Amendments to the Drawings:

REMARKS

Fig. 4E

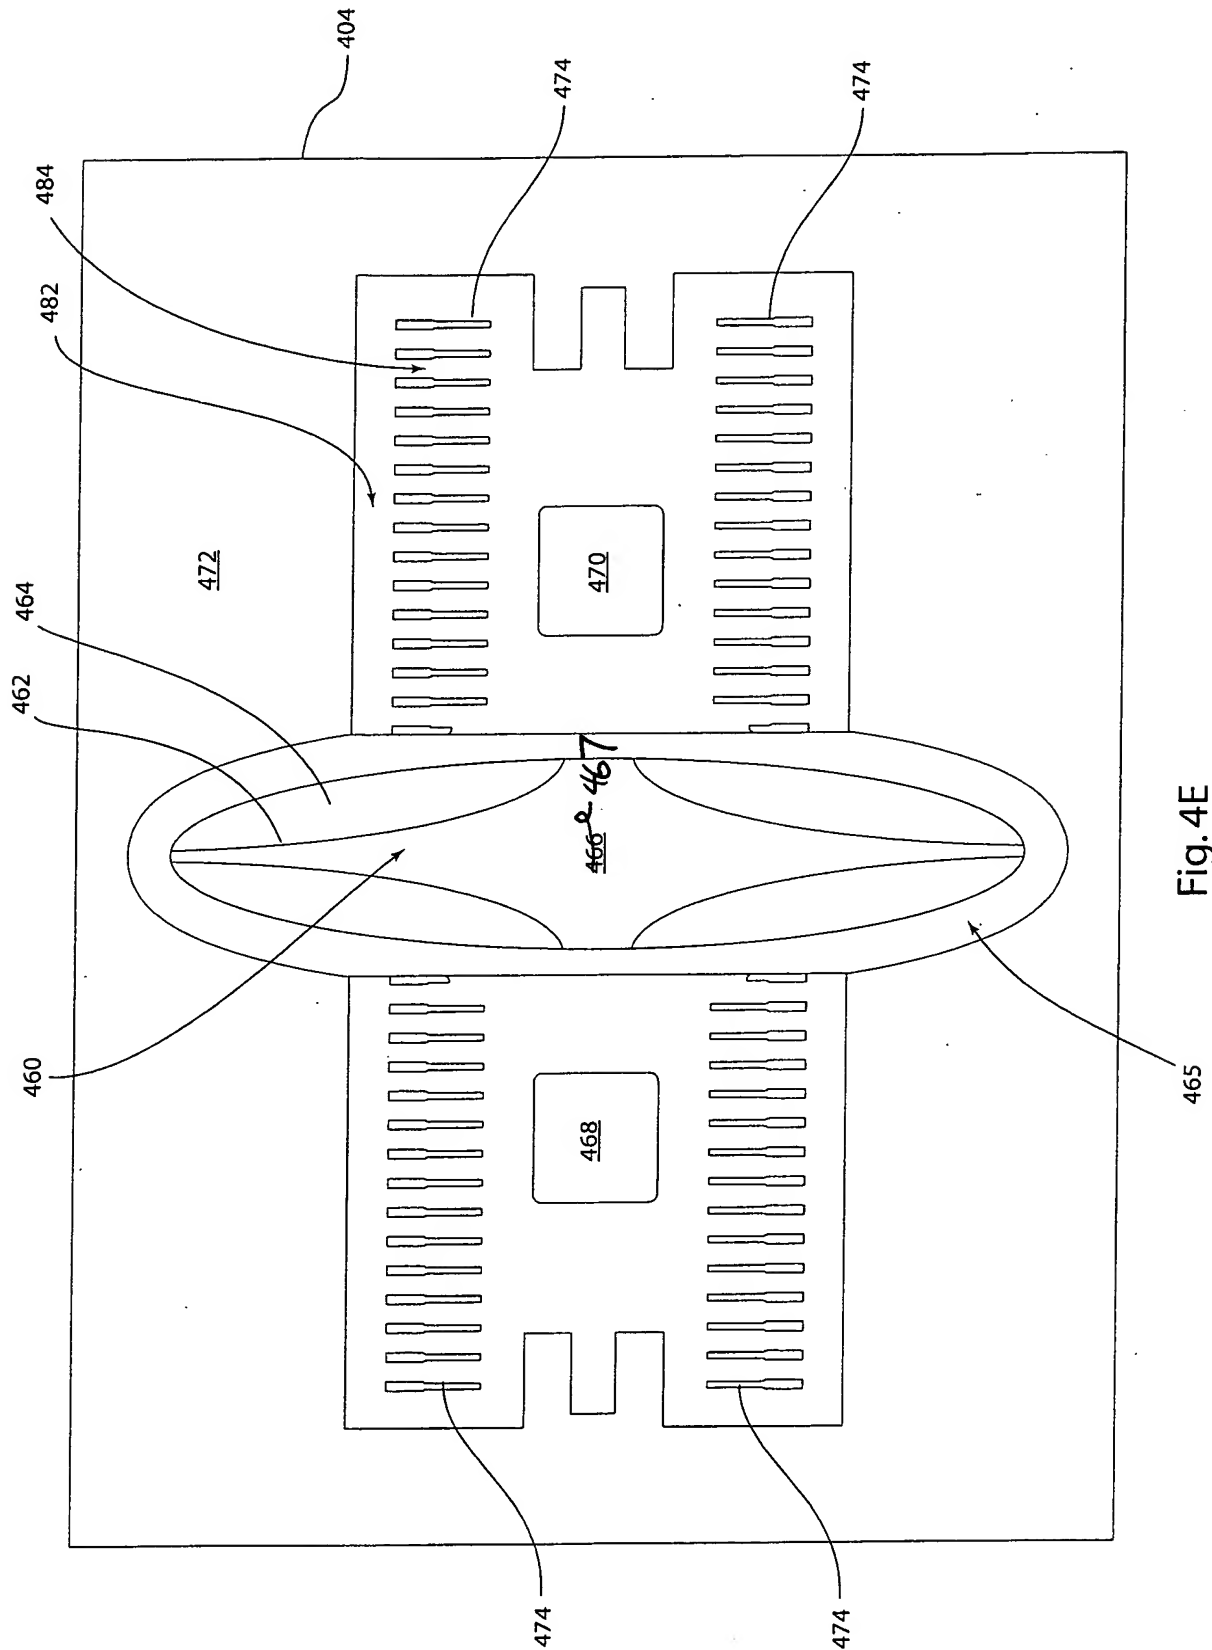
In Fig. 4E, Applicant has corrected a reference number 466 to 467. In Fig. 4F, Applicant has added a reference number 404. In Fig. 4G, Applicant has corrected a duplicative reference number 464 to 462, and added additional reference numbers 416, 434, and 474. Again, this is done to show the rotational and stationary comb teeth are interdigitated in-plane and out-of-plane. In Fig. 6C, Applicant has added a reference number 633.

Fig. 6F

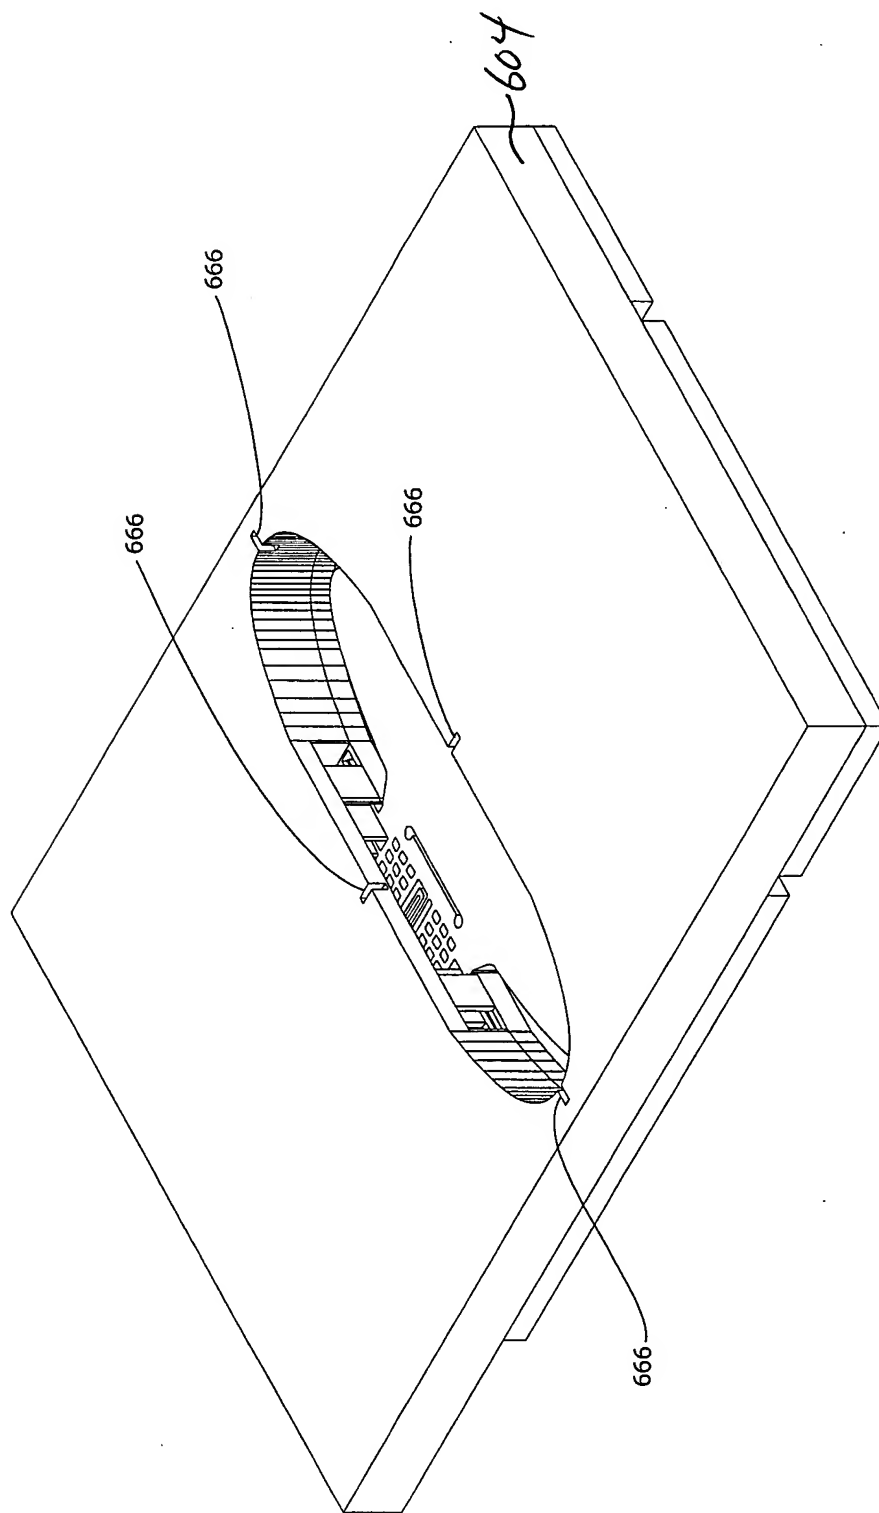
The Examiner objected to the drawings under 37 C.F.R. §1.83(a) because Figs. 6A to 6J do not show the second plurality of stationary comb teeth and the plurality of rotational comb teeth are interdigitated out-of-plane. Applicant has added Fig. 6F-1, which is a cutaway view of device 600. Fig. 6F-1 illustrates rotational comb teeth 634 and stationary comb teeth 616 being interdigitated in-plane, and rotational comb teeth 634 and stationary comb teeth 674 being interdigitated out-of-plane. Fig. 6F-1 introduces no new matter but merely illustrates what one in skilled in the art would deduce from Figs. 6A to 6F.
